Dewberry's Response to USGS' Review

NRCS Virginia LiDAR Project

G10PC00013

G11PD00336

Figure 2- Tile N16_4924_10, Delivery 1. The feature identified by the red dot was originally interpreted as a culvert and left in the ground surface. USGS identified this feature as a bridge. The LAS and DEM has been corrected by removing this feature from the ground surface, shown below.

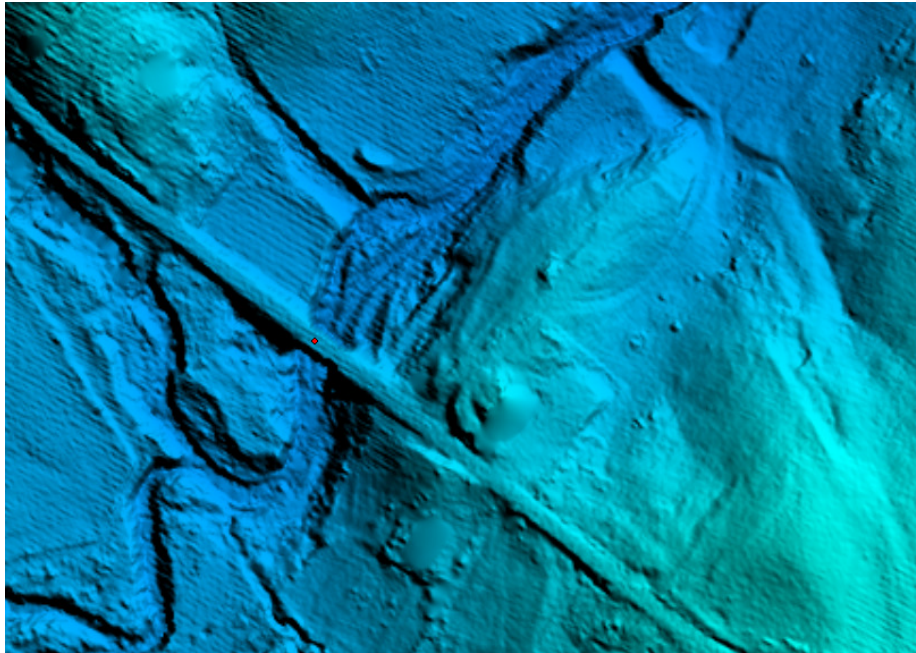
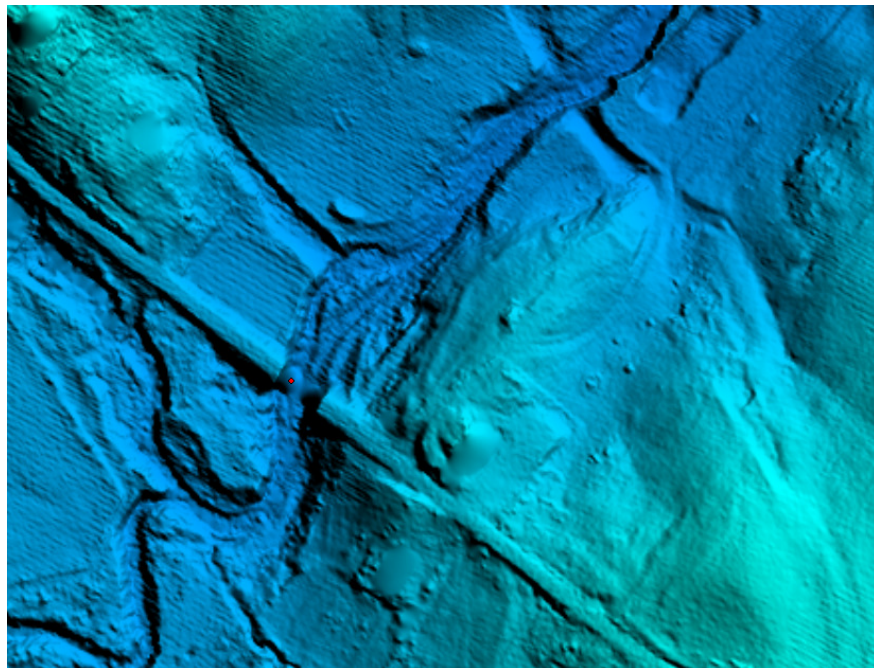
There are four locations where Dewberry interpreted a feature as a culvert and left the feature in the ground surface. USGS identified these features as bridges, not culverts. While the

interpretation of the feature may be questionable in the intensity imagery, Dewberry agrees with all four calls after reviewing color imagery. All four instances identified by USGS have been corrected. An example is shown below.

Figure 3- Tile N16_4924_10, Delivery 2. The bridge has been removed from the ground surface.

Figure 4- Tile N16_4921_20, Delivery 1. The feature identified by the red dot was originally interpreted as a bridge and removed from the ground surface. USGS identified this feature as a culvert. The LAS and DEM has been corrected by adding this feature back to the ground surface, shown below.

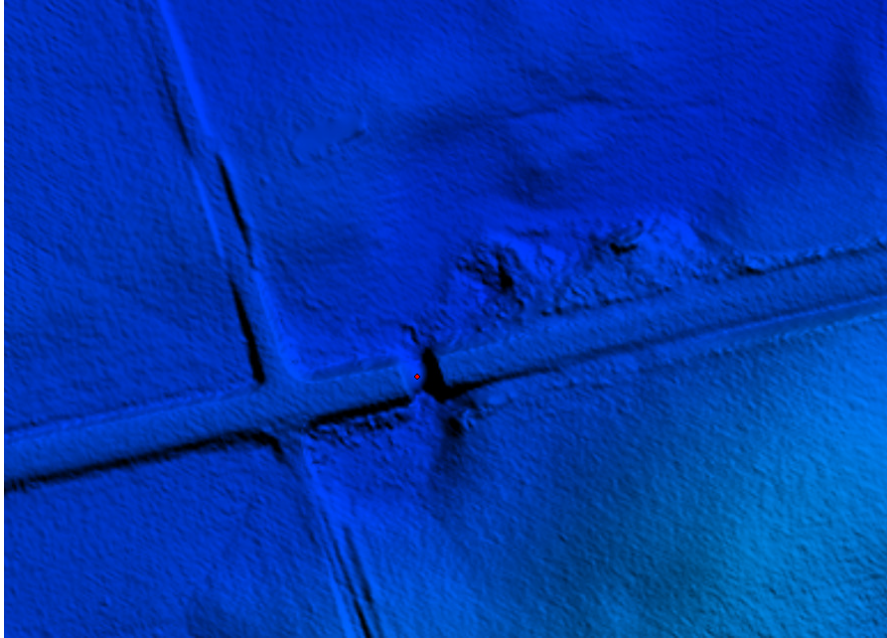
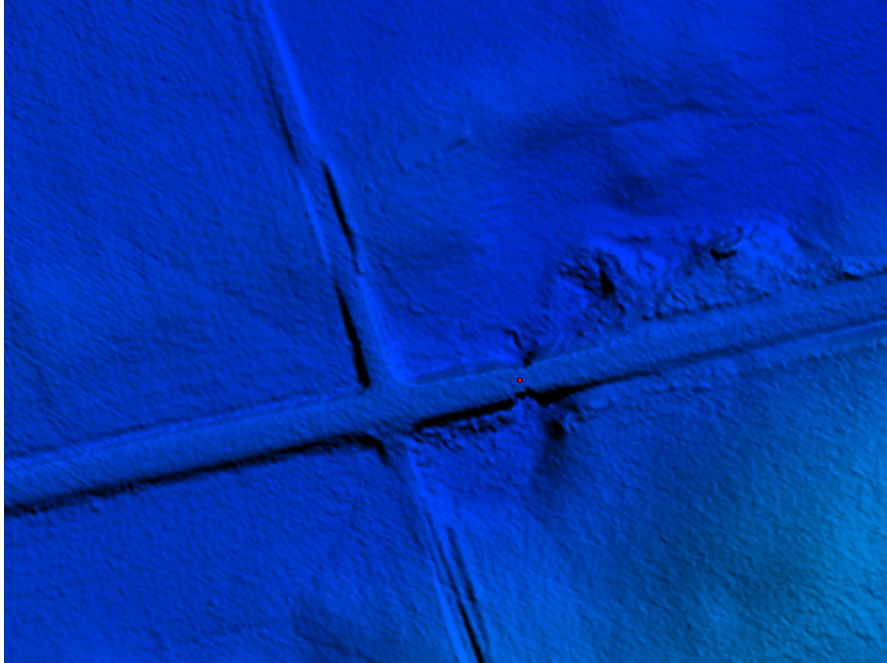
There are ten locations where Dewberry interpreted a feature as a bridge and removed the feature from the ground surface. USGS identified these features as culverts, not bridges. Dewberry agrees with all ten calls and all ten instances identified by USGS have been corrected. An example is shown below.

Figure 5- Tile N16_4921_20, Delivery 2. The culvert has been added back to the ground surface.

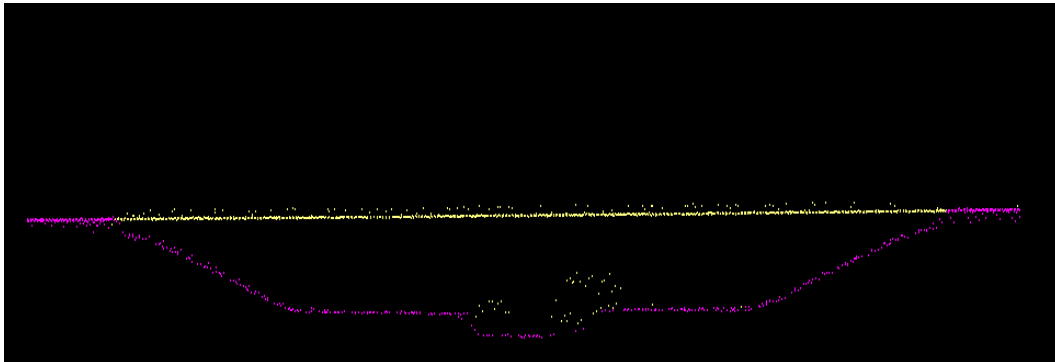
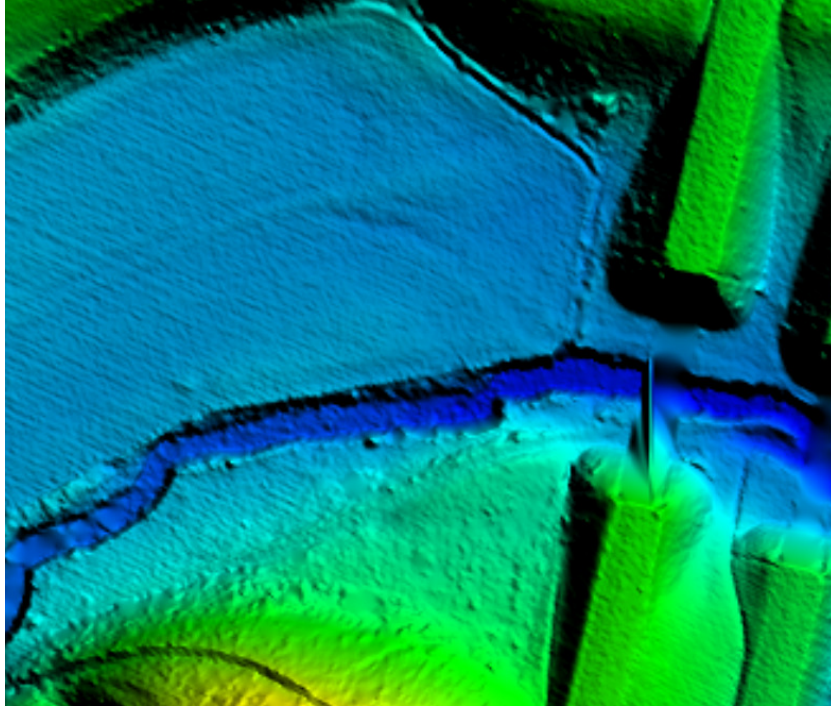
Two general comments, affecting 21 locations, were made for bridge removal artifacts. The DEM surface models are created from TINs or Terrains. TINs and Terrain models create continuous surfaces from the inputs, in this instance LiDAR ground point and breaklines. Because a continuous surface is being created, the TIN or Terrain will use interpolation to triangulate across a bridge opening from legitimate ground points on either side of the actual bridge. This can make the model appear to contain a bridge even though points have been removed from ground. This can also cause visual artifacts or “saddles,” as labeled in the USGS review document. As these “artifacts” are only visual and do not exist in the LiDAR points or breaklines, no modifications were made to the LAS or DEMs in these areas. Examples are shown below.

Figure 6- Tile N16_3734_10. The DEM in the top view shows a visual artifact because the surface model is interpolating from the slope leading to the bridge to the hydrographic banks. The surface model must make a continuous model and in order to do so, points are connected through interpolation. This can cause visual artifacts when there are features with large elevation differences. The profile in the bottom view shows the LiDAR points, colored by class, of this particular feature. All bridge points have been removed from ground (pink) and are unclassified (yellow). There are no ground points that can be modified to correct this visual artifact.
